Noguchi and WAGMC detailed correction instructions

Reconstruct the buildings and their surroundings accurately in LEGONRUSH using the 20 numbered references. Correct the site plan and surface types first, then the facade geometry, entrances, tower, wall spans, openings, signs and planting. This is a task specification for Claude, with mandatory evidence checks before completion.

WAGMC parking and entrance layout

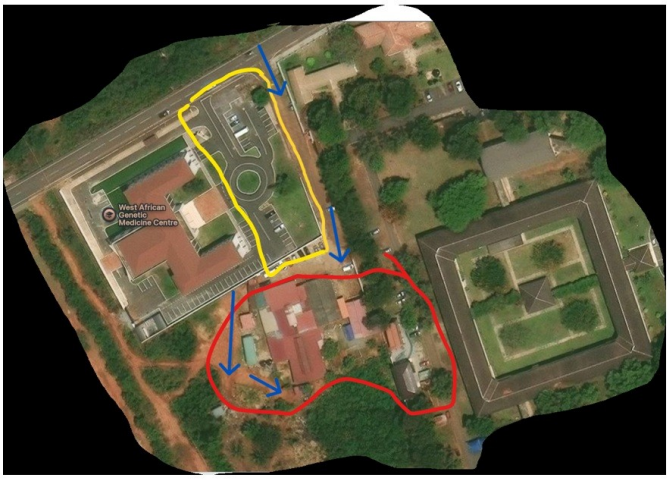
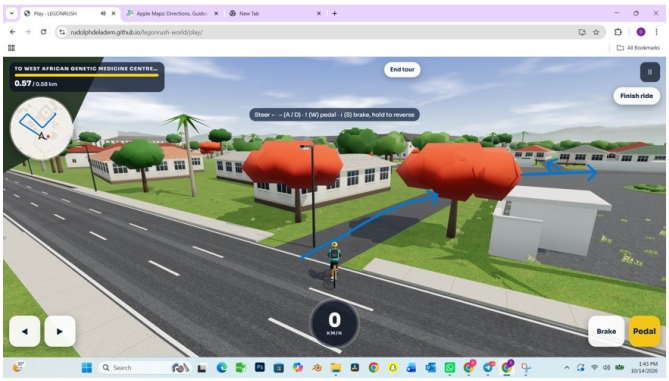
Visible mismatch The game has a broad simplified dark paved apron and a circular green motif. The yellow outlined real parking area is a specific narrow elongated layout with white bays, circulating access and several bounded planted islands including a round one.

Auxiliary zone The red outline identifies a distinct irregular roof cluster and mixed ground near the parking end. Register the blue arrows to actual routes, keeping this cluster separate from the large courtyard building on the right.

Required correction Trace the real paved perimeter, parking rows, planted strips and circular island from S02. Build physical kerbs and grass islands with correct adjacency; a circular decal on a large empty apron is insufficient.

Acceptance From the S02 overhead orientation, parking extent, island shapes, marked bays, entrance connection and auxiliary roof locations agree. Material boundaries remain legible at road level.

Additional WAGMC approach checks

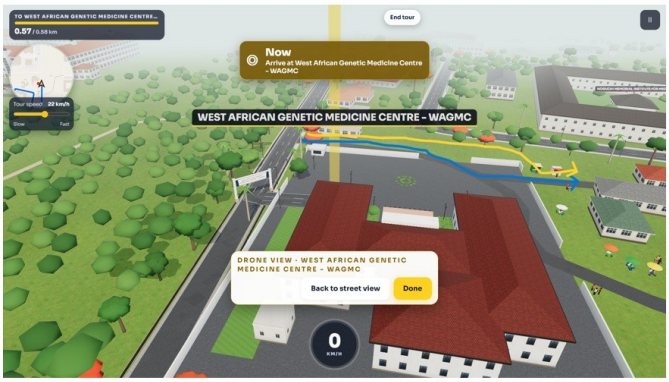
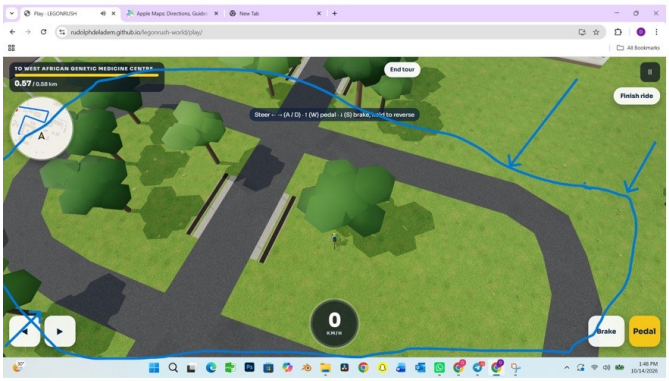
Purpose These are additional game perspectives of the circulation and auxiliary approach. They are not independent real targets. Compare their lane endpoints and offsets with S02 and S18.

Required correction Check every thin asphalt branch and apron where the arrows lead. Retain verified vehicle roads; replace unpaved red soil or service paths only where the satellite evidence supports that surface. Do not turn all paths grey merely because the game represents them as line segments.

Small structures Match each visible small block to an actual roof or confirmed utility object. Preserve irregular real spacing and access gaps. White rectangular placeholders must not establish invented buildings.

Acceptance After edits, both road level and aerial views show the same corrected surface regions, parking entrance, small structure locations and open circulation. Buildings and colliders do not cut across a verified path.

Loop beside the older institute

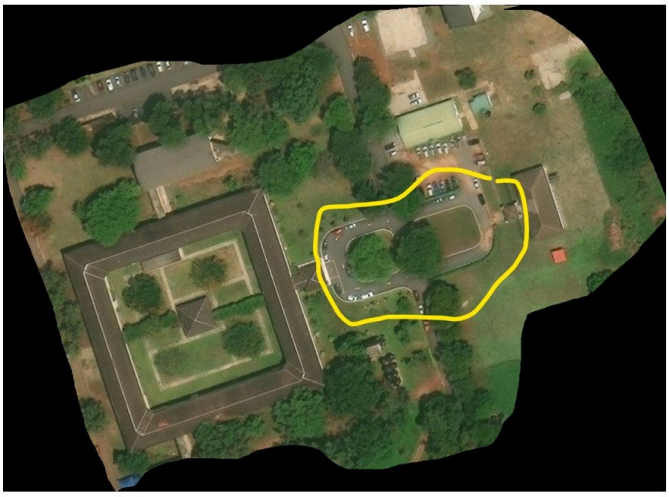
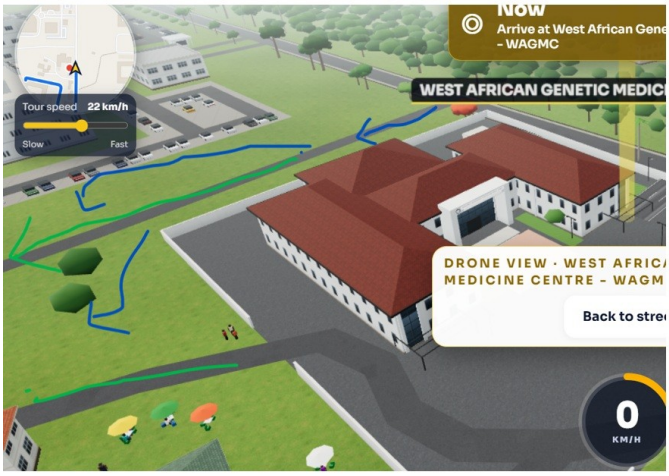
Visible mismatch S03 shows a broad simple loop with grassy interior and arbitrary large trees. The yellow marked real loop in S04 has a specific rounded rectangular or irregular perimeter, parking on portions of the edge and a shaped central green area with trees.

Required correction Register loop endpoints and adjacent older courtyard building. Trace the real outer edge and inner planted boundary; preserve local parking and adjacent building access. Do not derive geometry from the yellow marker stroke thickness.

Surface distinction The loop is a real paved access and parking area. Do not replace it with red soil as part of the nearby unpaved corridor correction. Internal planted areas and surrounding earth remain separate.

Acceptance Overhead loop shape and parking distribution match S04; road level shows physical kerbs grass and correctly placed trees with clear access.

Laboratory facade and entrance mismatch

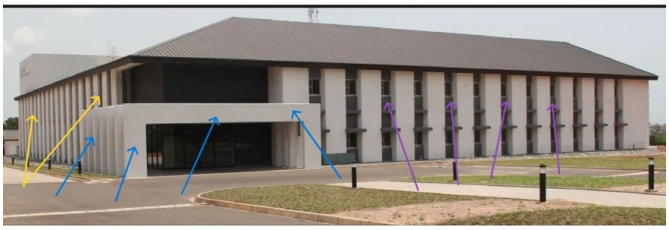
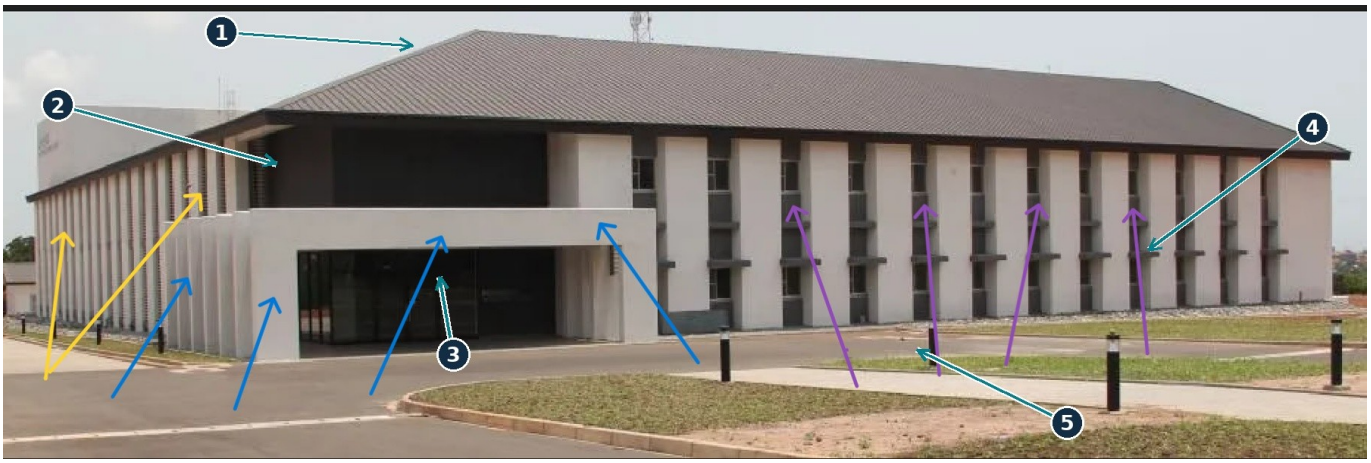
Visible mismatch The game has generic thin dark full height stripes and a simplified central entry. The real facade has substantial light vertical piers or fins, narrow recessed framed window stacks, small projecting grey shelf bands and a deep rectangular entrance portal with dark recessed glazing.

Required correction Rebuild the correct mass and bay schedule. Separate solid pier faces from window slots, floor divisions and recess depth. Model the heavy portal and the upper dark bay as distinct features.

Acceptance At the S08 angle the entrance projects correctly, bays have real width and depth, the upper dark recess and roof align, and no false glass stripe replaces a blank pier.

Aerial and dusk checks on the same ensemble

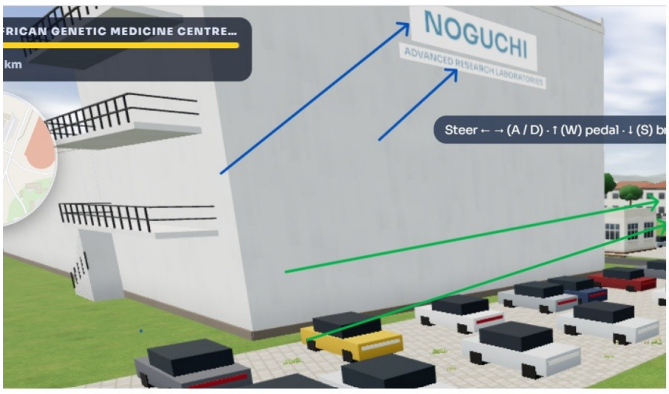
Aerial evidence S09 establishes the long roof mass, rear pale flat roof/service volumes, equipment, taller end element, parking edge and routes. The rear is not another copy of the front pitched roof.

Tower evidence S10 shows the end tower rising above the lower main mass and its side projection through the tree. This corroborates the end volume seen in S15 and S19; it does not establish every concealed face.

Acceptance Overhead and ground views describe the same roof and rear volume arrangement. Trees and lighting do not conceal a mislocated tower or missing rear block.

Tower wall length and opening requirements

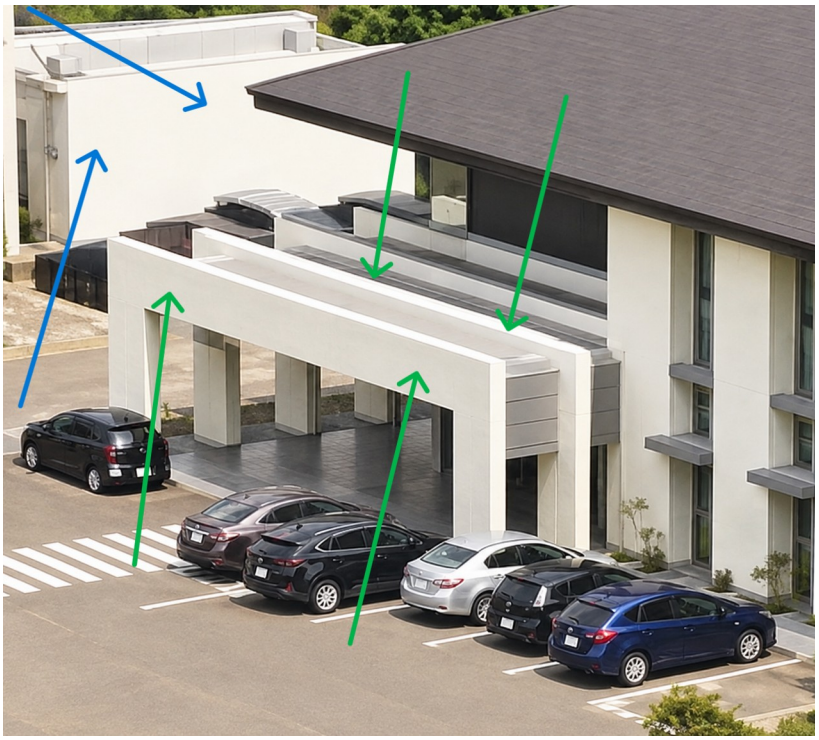
Visible mismatch The game has simplified hanging balcony rail slabs on a broad blank tower, and a coarse parking area. The real end has stacked exterior landings linked to a ground stair, proper slab supports or returns, a projecting sign wall and a long returning finned elevation.

Match the end volume Use the tower corner, long wing roof edge and parking alignment across S09/S15/S19. Check width depth and facade orientation before fitting signs or balcony parts.

Landing schedule Record the visible landing tiers, rails, slab projections and ground stair from S15. Do not invent extra balconies on unseen faces or assume a landing tier equals a full new occupied storey.

Rail construction Use thin vertical rail bars and supported slabs. Existing game floating balcony strips must be connected to the observed walls/supports. Ground stairs need real treads and continuous access where shown.

Wall span Trace the long side wall through repeated fin or window bays. Maintain the blank tower wall and service return. Wrong overall length must be corrected with adjusted bay count or spacing based on evidence, not stretched window textures.

Sign material Use separate raised light letters with subtle shadow on the pale wall. Do not apply a large glowing white rectangle or assign the sign to an unrelated facade. Small letter spacing stays proportional.

Entrance island and monument sign

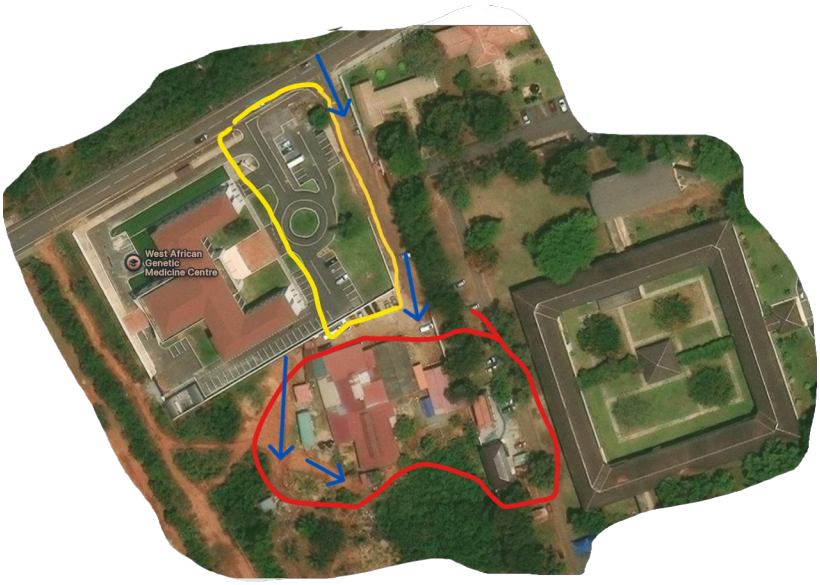
1 Lower entry Dark recessed glazed doorway under the portal. Do not make the entrance a flat black square without frame or depth.

2 Portal and upper bay The portal header supports a distinct wide upper dark recess under the pitched roof. Keep those two regions separate.

3 Freestanding sign The pale textured monument has an outer rectangular frame and inset rough face with stacked lettering. This is separate from the raised wall sign in S19.

4 Kerb and paving Curved pale kerb encloses a shaped grass/planting island beside asphalt and light pedestrian paving. Do not make the island a simple lawn rectangle.

5 Planted surface Low shrubs in a soil bed around the sign, adjacent green grass and yellow flower or groundcover band. Keep each region and short bollard positions legible.

Entrance lawn Use S20 to trace the shaped grass island, curved kerb, flower band, soil bed and paved walkway. Use restrained variation; bare soil around shrubs must not become grass everywhere.
